PARADIGM
BUILDING DESIGNS

Site Address:
2 Kingfisher Close,
Kirkby,
L33 4DP

Drawing Title:
Proposed Plans

Project No:	Drawing No:	Scale @ A1	Revision:
25.009	101	1 : 50	P01

Proposed First Floor Plan

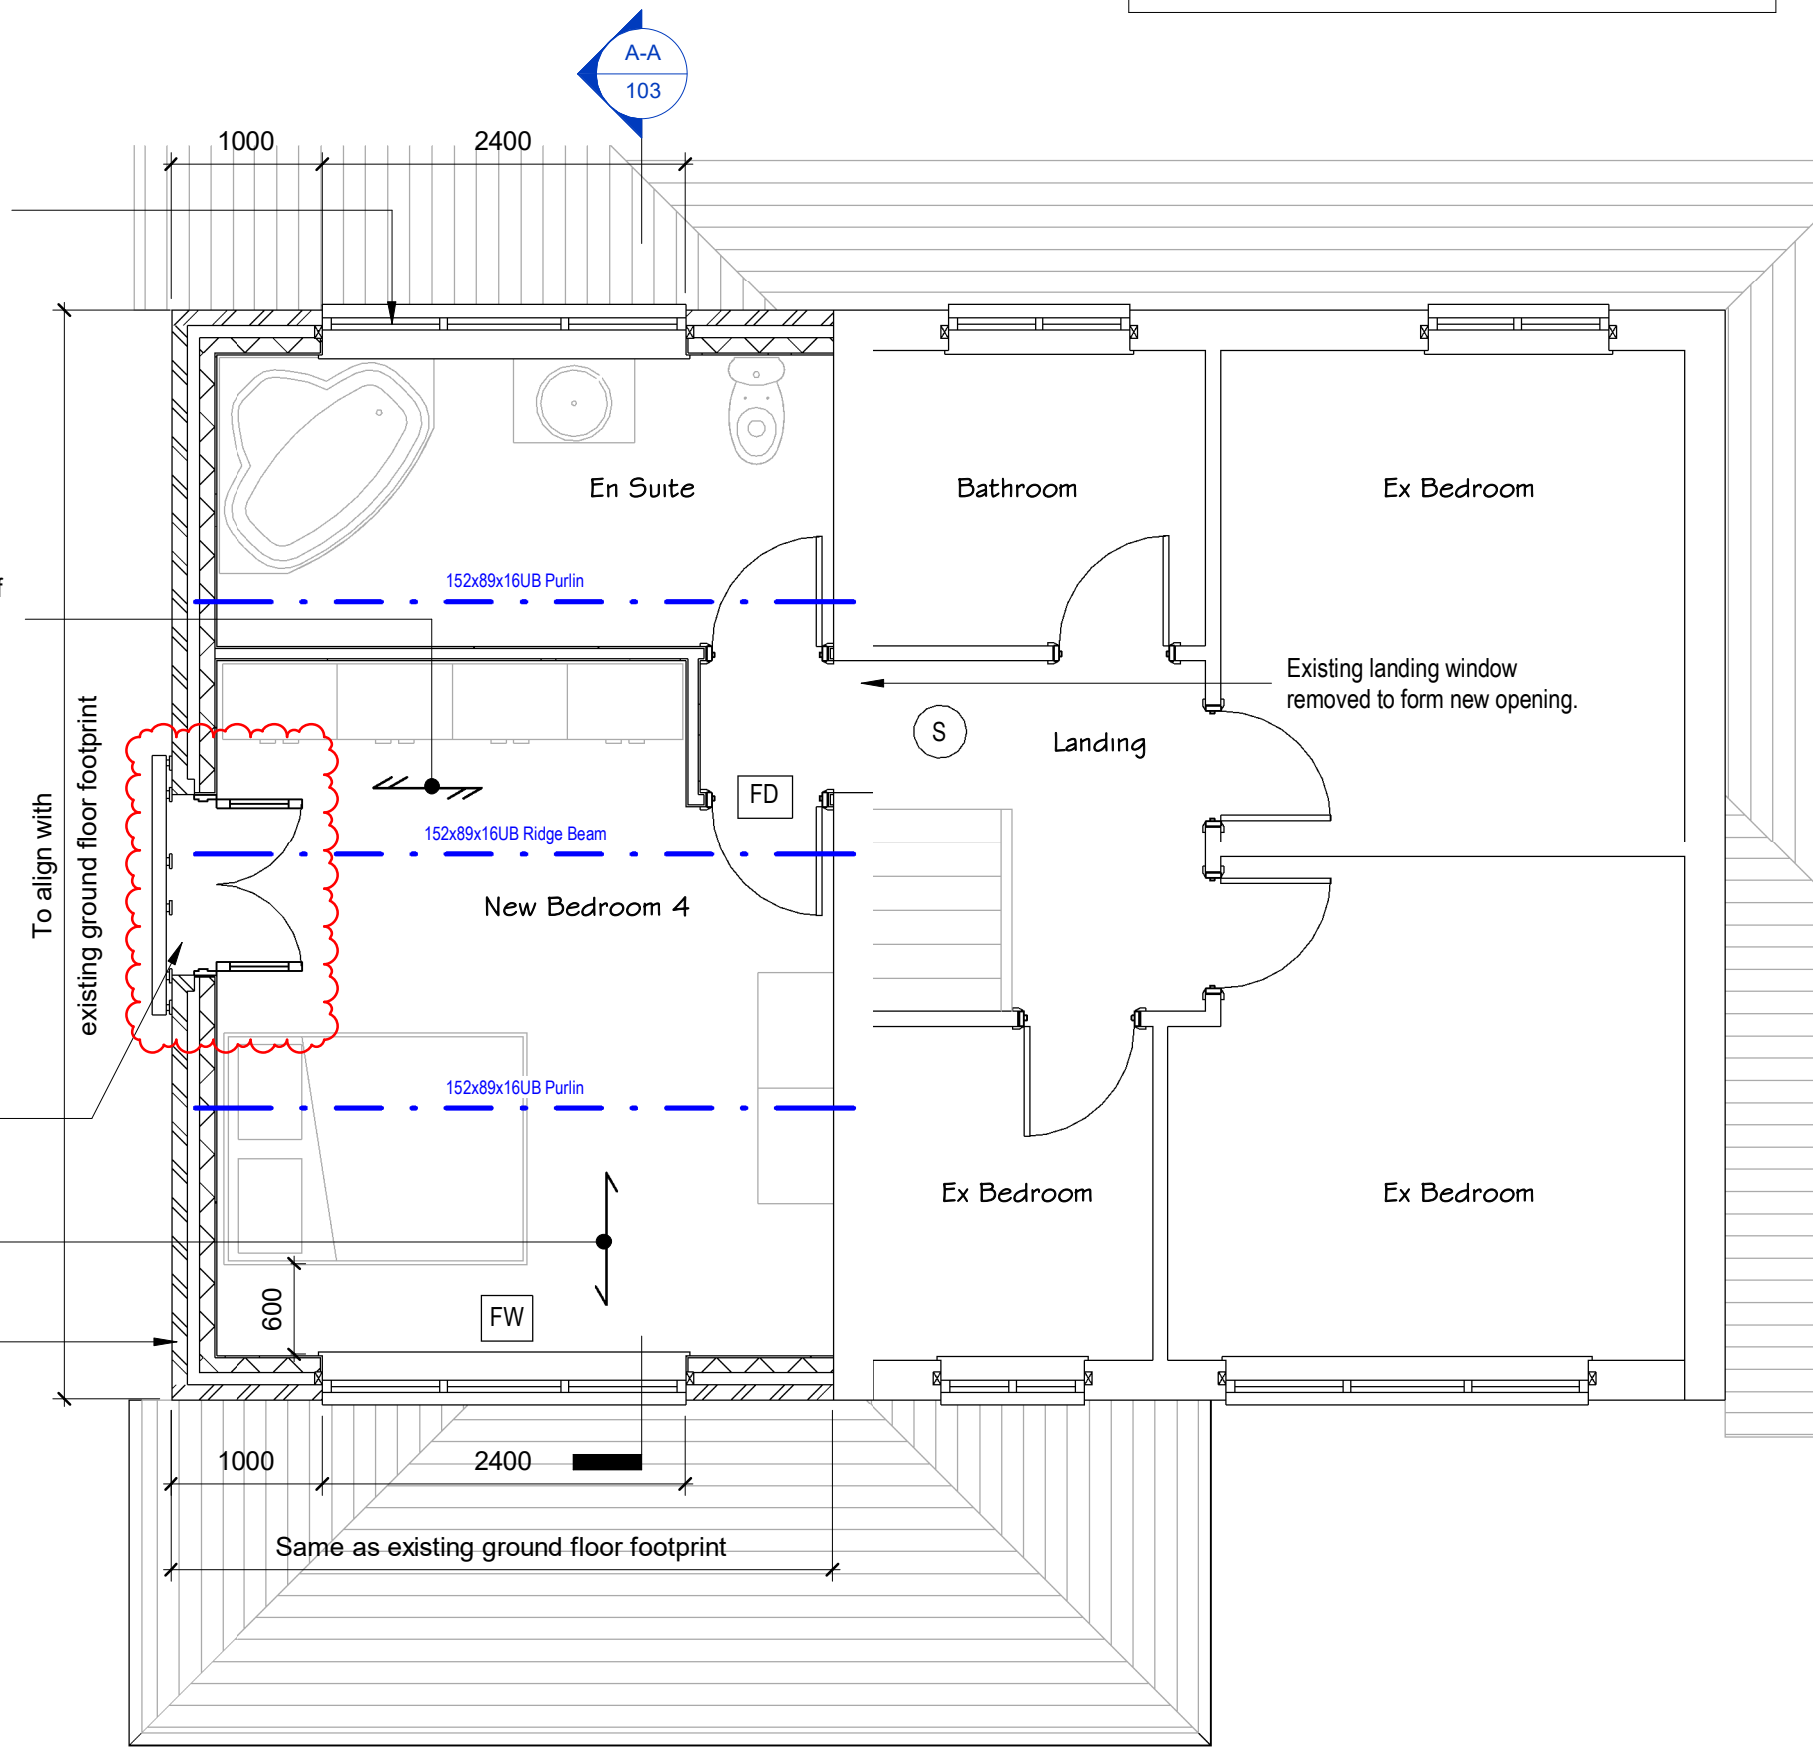
Rev	Description	Date
P01	Juliet balcony added to the (south-facing) side elevation. Submitted to Planning as a Non-Material Amendment application. Revised as cloudd.	13.02.2026
